GUIDE TO PROPOSED UNIT 3
TECHNICAL SPECIFICATION CHANGES

APPLICABLE TO:
PUBLICATION NO. NEDO-24199
T. I. E. NO. 79 NED-281
TITLE Browns Ferry Unit 3
Reload 2 Supplemental
Licensing Submittal
ISSUE DATE June 1979

ERRATA And ADDENDA SHEET

Figure A-1. Browns Ferry Cycle 3 - Plant Response to Generator Load Rejection Without Bypass
(Two Crosby SRVs Set at 1150 psig)

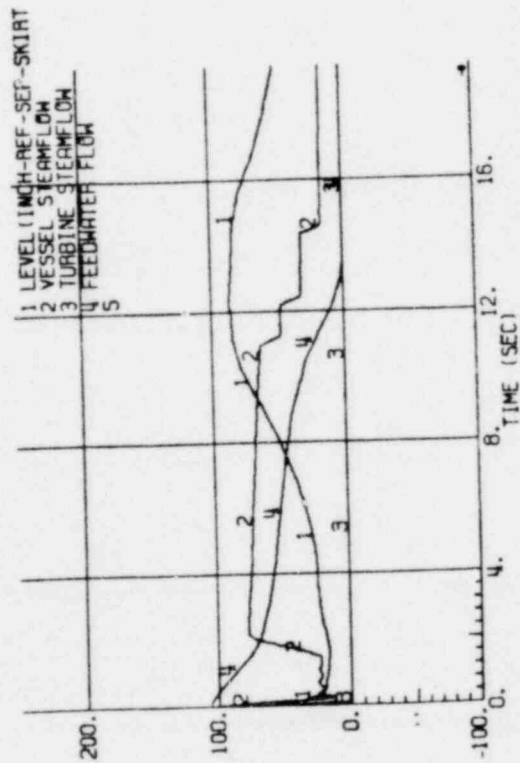
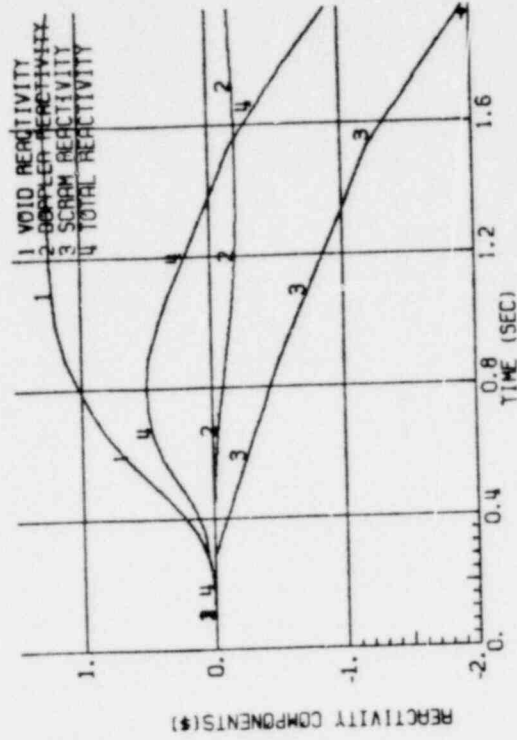
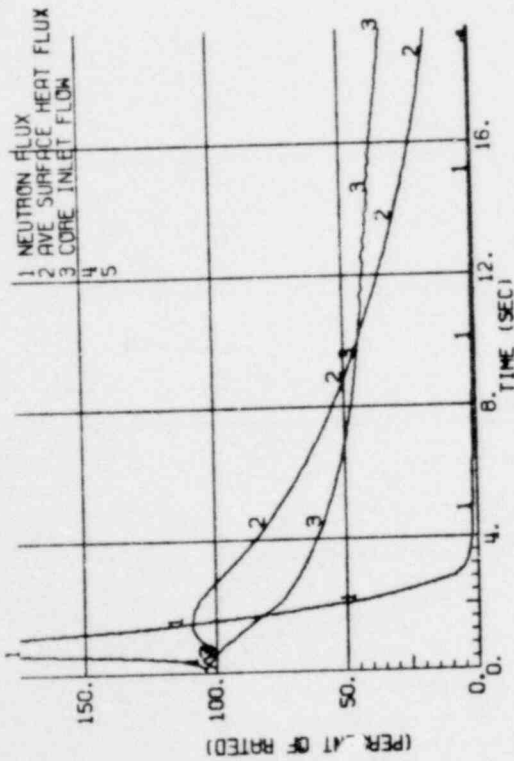
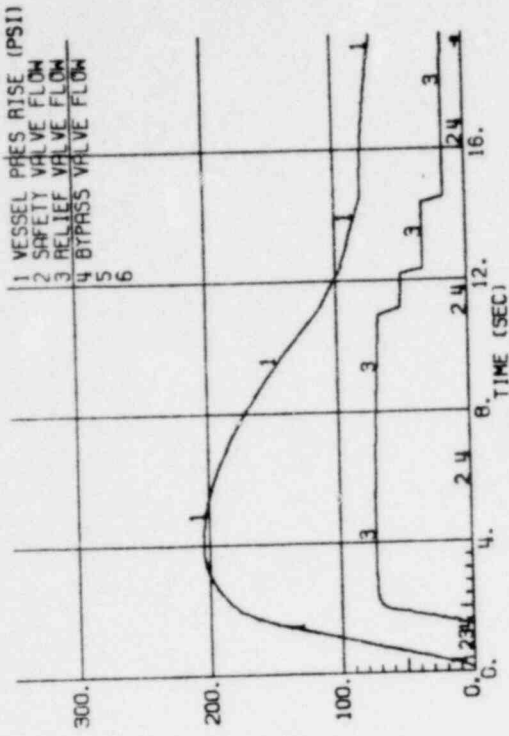
For Browns Ferry 3 cycle 3, transient analyses for the limiting transients have been performed to evaluate the impact of using the 2 Crosby Safety Relief Valves set at 1150 psig instead of 2 high set Target Rock SRVs, and the plant responses are indicated in Figure A-1 and A-2 which are similar to previous Figures 3 and 7, respectively. The analyses presented used preliminary estimates of the capacity of the Crosby SRVs as 75.5%. These analyses are conservative when applied with the actual value of the valve capacity (94.3%).

Transient	Exposure	Power (%)	Core Flow (%)	Q/A (% NBR)	Q/A (% NBR)	P _{sl} (psig)	P _v (psig)	8x8	ΔCPR 8x8R	P8x8R	Plant Response
Load Rejection without Bypass	BOC-EOC	104.5	100	229.5	109.3	1218	1243	0.15	0.15	0.16	Figure A-1

Figure A-2. Browns Ferry Cycle 3 - Plant Response to MSIV Closure, Flux Scram
(Two Crosby SRVs Set at 1150 psig)

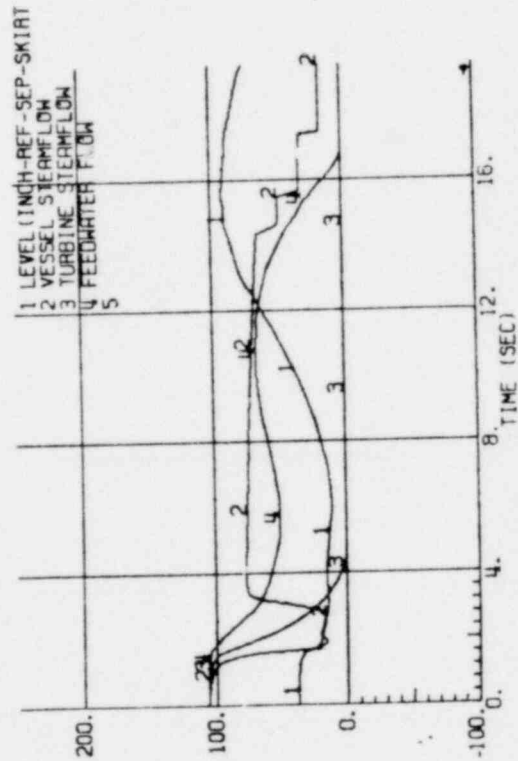
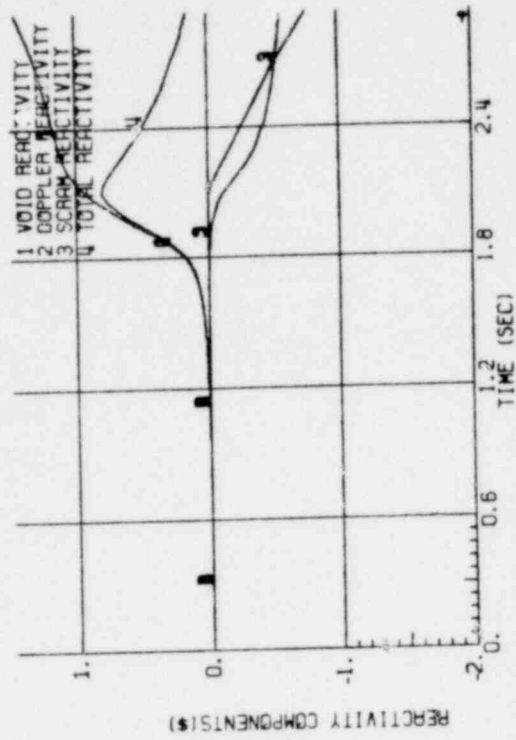
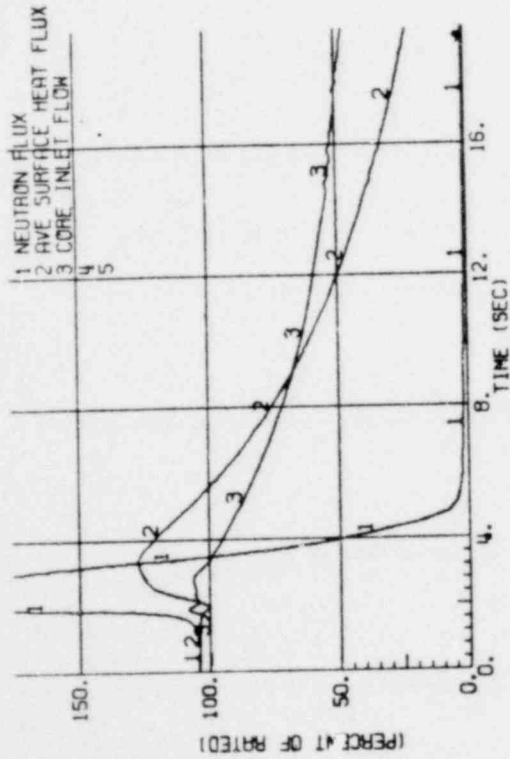
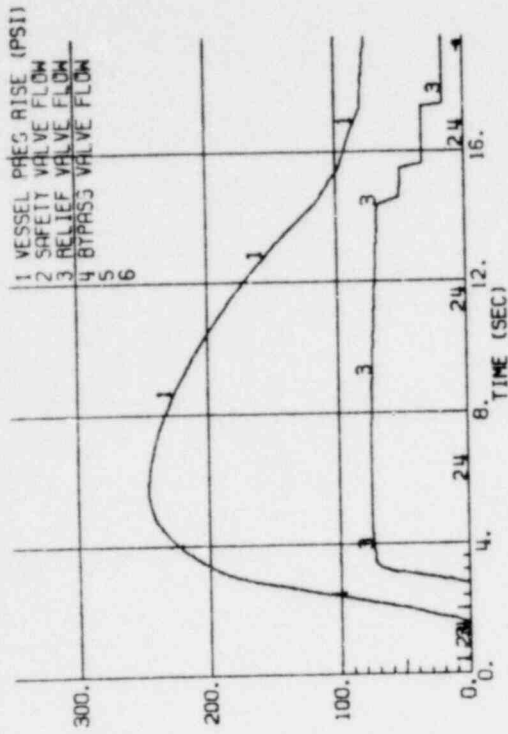
Transient	Power (%)	Core Flow (%)	P _{sl} (psig)	P _v (psig)	Plant Response
MSIV Closure (Flux Scram)	104.5	100	1260	1293	Figure A-2

The peak vessel bottom pressure increased 13 psi to 1293 psig, but it is still well below the limit of 1375 psig for vessel overpressure protection.
